HARTZELL PROPELLER INC.
SERVICE LETTER
HC-SL-61-346
Spinner - Bulkhead Modification

- (1) This Service Letter provides Additional Maintenance Information (AMI).
- (2) This Service Letter provides instructions for adding drain holes to affected spinner bulkheads.

Spinner Bulkhead Drain Hole Location
Figure 1

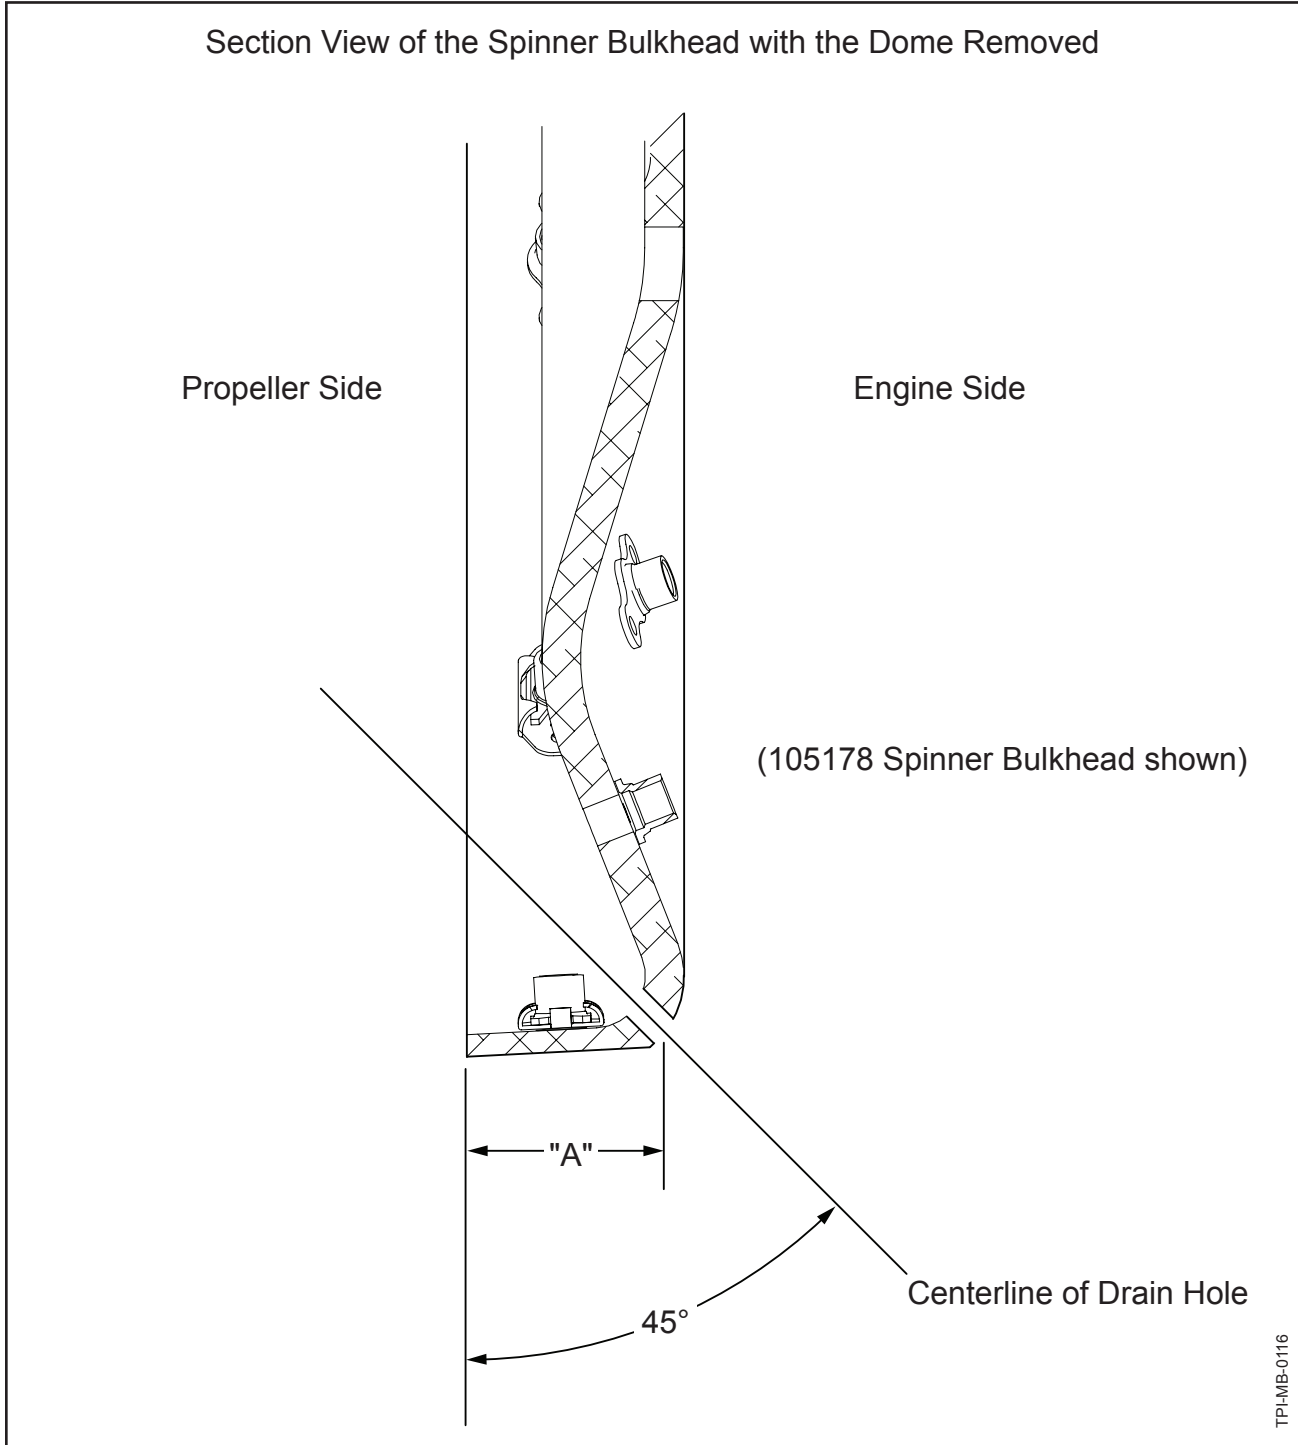
- (1) Hartzell Propeller Inc. has received reports of water accumulating inside the spinner dome on spinner assemblies that use the affected spinner bulkheads.
 - (a) In certain conditions, the accumulated water can freeze and cause the propeller to be out of balance.
- (2) Hartzell Propeller Inc. has redesigned the 104154 and 105178 spinner bulkheads with evenly spaced drain holes to prevent water accumulation inside the spinner dome.
 - (a) Hartzell Propeller Inc. spinner assemblies 104552 and 105180 will include the redesigned 104154 and 105178 spinner bulkheads with drain holes when production/manufacturing changes are implemented.
 - (b) The spinner bulkhead modification procedure in this Service Letter provides instructions for drilling the drain holes in affected spinner bulkheads manufactured before the design change.
- (3) Regulatory action is not expected.

- (1) The following procedure may be performed on-wing by a certified aircraft mechanic with the appropriate rating or by a certified propeller repair station with the appropriate rating.
- (2) Remove the spinner dome in accordance with Hartzell Propeller Inc. Propeller Owner's Manual 147 (61-00-47).
- (3) Using a center punch, mark the location of the five holes to be drilled in the outside radius of the spinner bulkhead. Refer to Figure 1 and Table 1.
 - (a) The drain holes must be evenly spaced from each other at the midpoint between the blade cutouts.
 - (b) Refer to Table 1 for dimension "A"

- (4) Using a 0.250 inch diameter drill bit, drill five holes through the spinner bulkhead.
- (5) Deburr both the inside (engine-side) and outside (propeller-side) of the holes using a deburring tool.
 - (a) If the inside of the bulkhead is difficult to access, it may be deburred the next time the propeller is removed. The outside must be deburred to avoid damage to the spinner.
 - (b) Remove all metal shavings caused by drilling/deburring the drain holes.

Spinner Bulkhead	Dimension "A"	Additional Instructions
104154	1.050 ±0.010 inch (26.67 ±0.25 mm)	Center the hole between the fixed nutplates
105178	0.950 ±0.010 inch (24.13 ±0.25 mm)	Center the hole over the fixed nutplate
